**AMENDMENTS TO THE DRAWINGS:**

**Amendments to the Drawings**

Figures 17A and 17B are hereby amended to correct obvious mistakes. Channel current region 20 and tunnel current region 21 were either misplaced or not shown in original Figures 17A and 17B, as would be obvious to one of ordinary skill in the art upon reading the specification. For example, Figure 14 represents an example of a “fifth embodiment” that is described in the specification at page 33, line 23, to page 36, line 24. Figures 17A and 17B are described as “cross-sectional views showing a memory cell according to a modification example of the fifth embodiment” in the specification as originally filed (pg. 36, lines 5-7). The specification further states that “[t]he memory cells of the modification example can obtain the same effect as the fifth embodiment” (pg. 36, lines 20-21). One of ordinary skill in the art, upon reading the specification, would understand that channel current region 20 and tunnel current region 21 are properly shown as in amended Figures 17A and 17B, such as to be consistent with the specification and Figure 14.

FIG. 17A

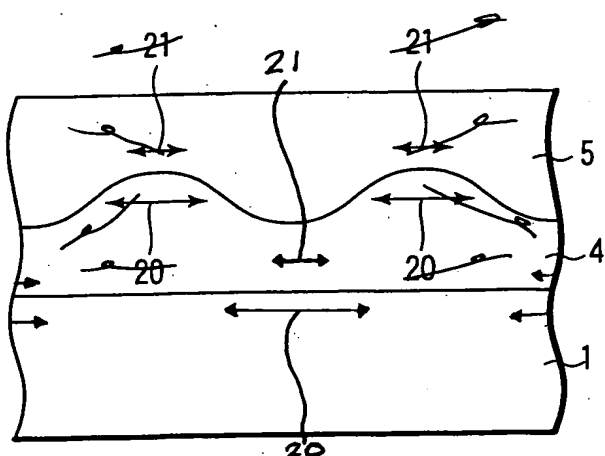
The original specification states that channel current region 20 is located in silicon substrate 1, and that tunnel current region 21 is located in tunnel insulating film 4. For example, the specification explains that channel current region 20 is “a region ... where channel current flows in the cell transistor operation” (pg. 34, lines 10-12), and Figure 14 shows that channel current region 20 is located in “silicon substrate 1.” The specification also explains that tunnel current region 21 is “a region ... where tunnel

current flows in the write/erase operation” (pg. 34, lines 13-14), and Figure 14 shows that tunnel current region 21 is located in “tunnel insulating film 4.”

Furthermore, one of ordinary skill in the art would know, in view of the original specification, that channel current region 20 and tunnel current region 21 should be at the particular locations shown in amended Figures 17A and 17B. Applicants advise that one of ordinary skill would know that (i) the channel current flows through an inversion layer at a surface region of the substrate 1, (ii) the channel current is concentrated in sections of increased vertical electric field intensity, and (iii) the regions of increased vertical electric field intensity are sections of the surface region of the substrate 1 that are arranged under the smaller thicknesses of the tunnel insulating film 4. Applicants also advise that one of ordinary skill would know that the (i) the tunnel current flows through the tunnel insulating film 4, (ii) the tunnel current is concentrated in sections of increased vertical electric field intensity, and (iii) the regions of increased vertical electric field intensity are sections of the tunnel insulating film 4 having smaller thicknesses. Thus, the particular locations of channel current region 20 and tunnel current region 21 that are shown in amended Figures 17A and 17B correct obvious mistakes in the original versions of these drawings.

In addition, the illustration in amended Figures 17A and 17B of channel current region 20 as larger than tunnel current region 21 is supported in the original specification. For example, the specification explains that “the channel current region 20 has the larger area than the tunnel current region 21” (pg. 34, lines 15-16), and this relationship is also shown in Figure 14. Thus, the amendments to Figures 17A and 17B correct obvious mistakes and add no new subject matter.
